**ADDENDUM NO. 4**

Project: **STEPHENSON SCHOOL BUILDING & PARKING IMPROVEMENTS**

Owner: **City of Dripping Springs, Texas**  
311 Old Fitzhugh Rd  
Dripping Springs, Texas 78620

Respondents are hereby notified of the following revisions and/or clarifications to the construction plans, contract documents and specifications. This Addendum forms a part of the Contract and clarifies, corrects, or modifies original Proposal Documents.

9 Unit Pavers on Concrete Base

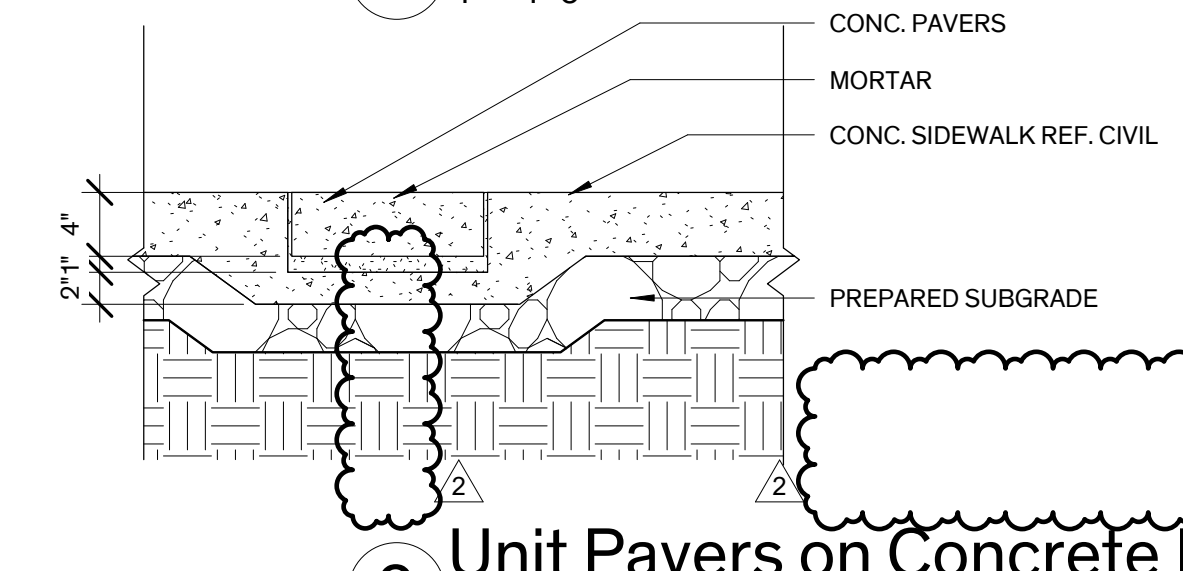
3. Question: Sheet A1.01/Sheet A1.03 Detail 9 – 3" OD PVC Pipe is shown per row of pavers. Please advise pipe termination. Does this tie into storm drainage?

UPDATE – Update detail 9/A1.03 – Remove PVC pipe drain from detail.

*Response: Delete 3" OD PVC pipe from paver paving at building as shown in 9/A1.03.*

3 East Ramp Detail Section

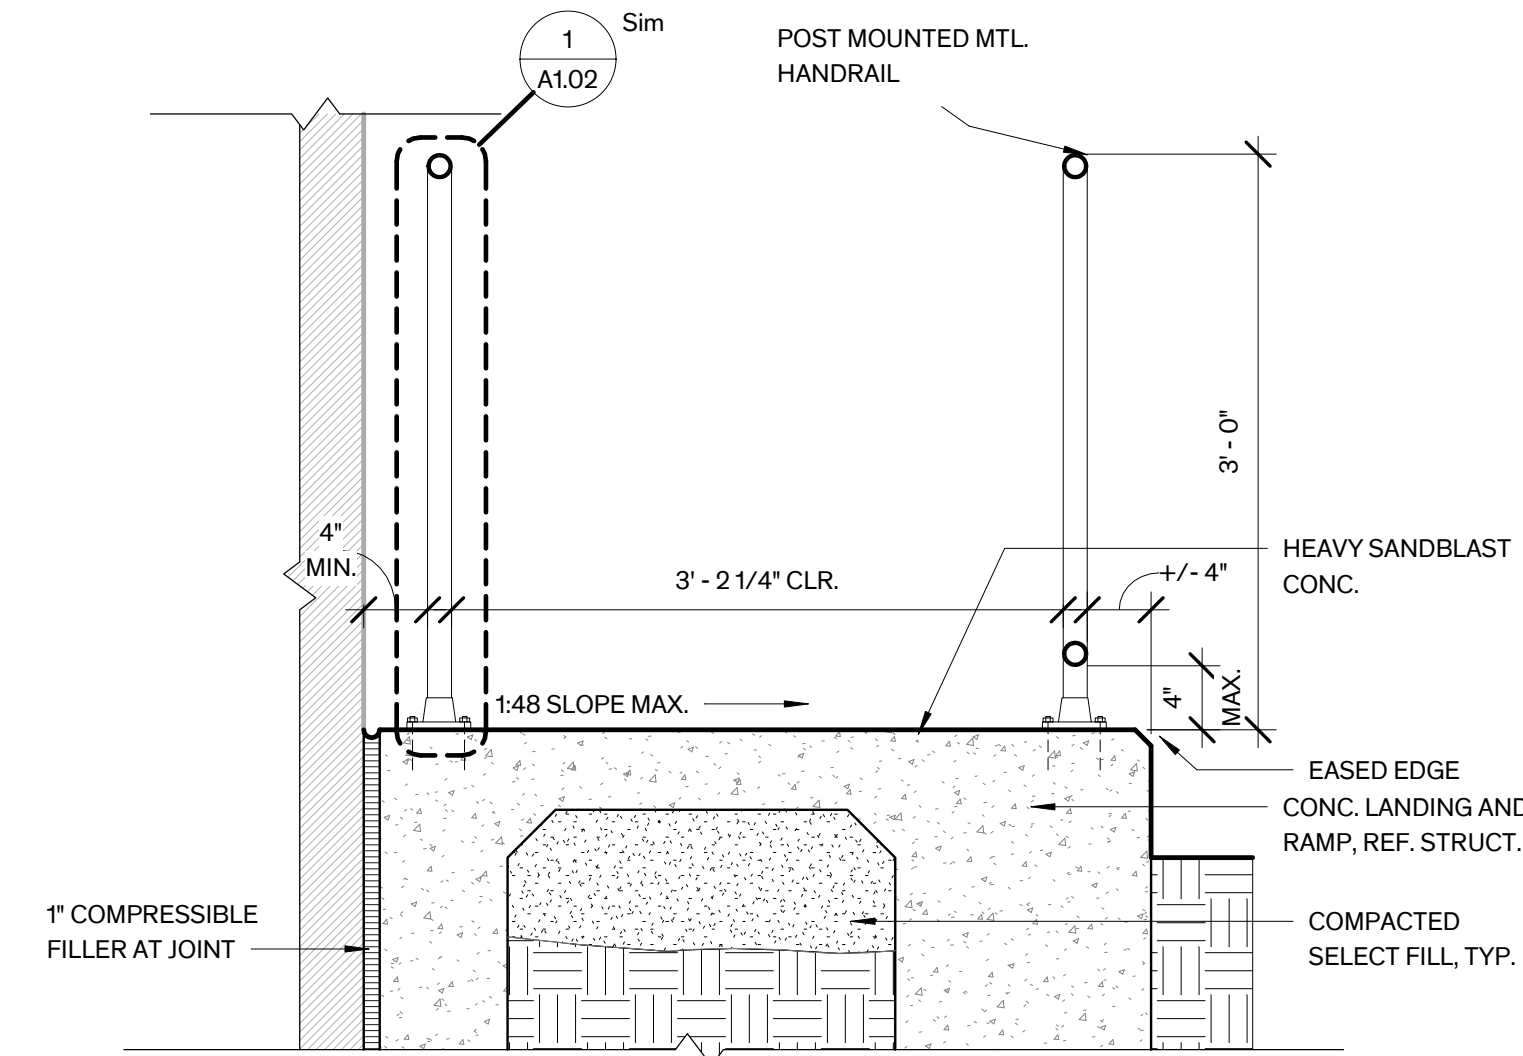
1. Question: Sheet S2.01 – Has note at the ramp referencing detail 6/S3.03. Sheet S3.03 does not show detail 6, please advise.

*Response: The reference detail is incorrect. Please refer to 3/S3.10.*

ADA Legend - NTS.

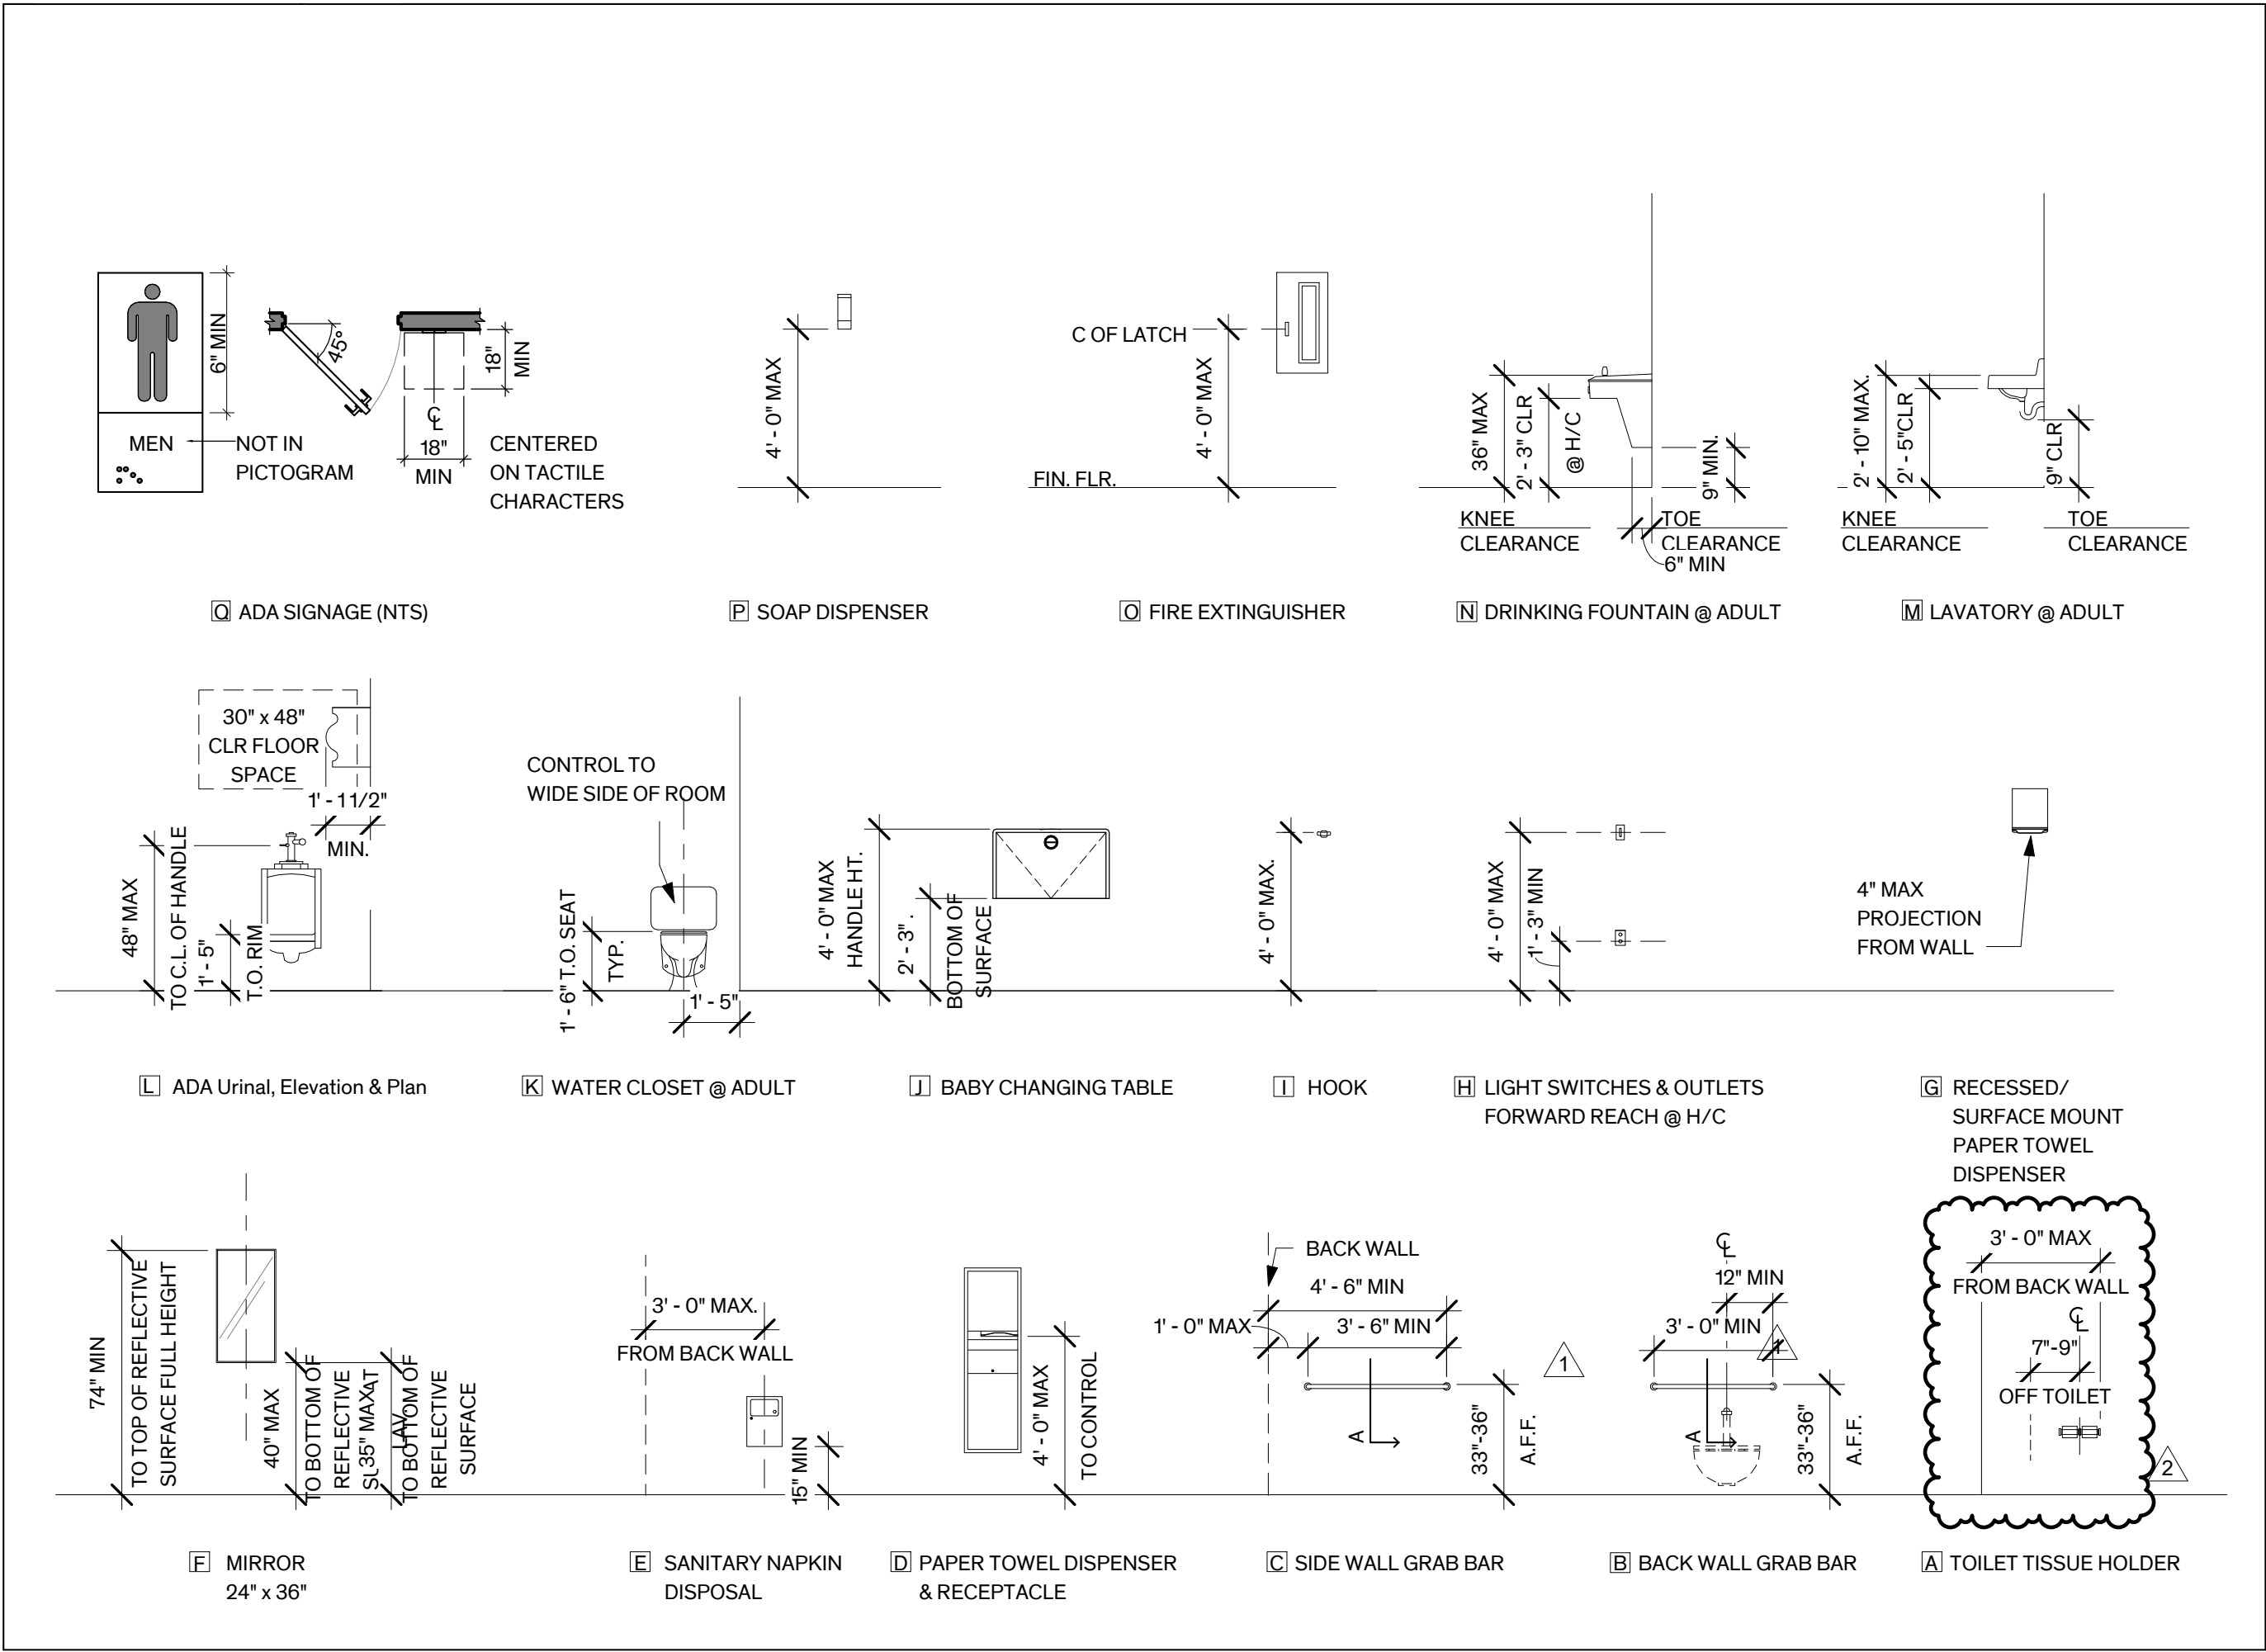
9. Question: Sheet A6.03 / Detail 6 – Drinking Fountain Backsplash is labeled as “N”. Please confirm material.

UPDATE – Update ADA legend dimension for fixture A & Lav centerline dimension for RR 9.

*Response: Please refer to the ADA legend on A6.01 for the mounting heights of the drinking foundation labeled as “N”. The fixture is schedule on sheet P301.*
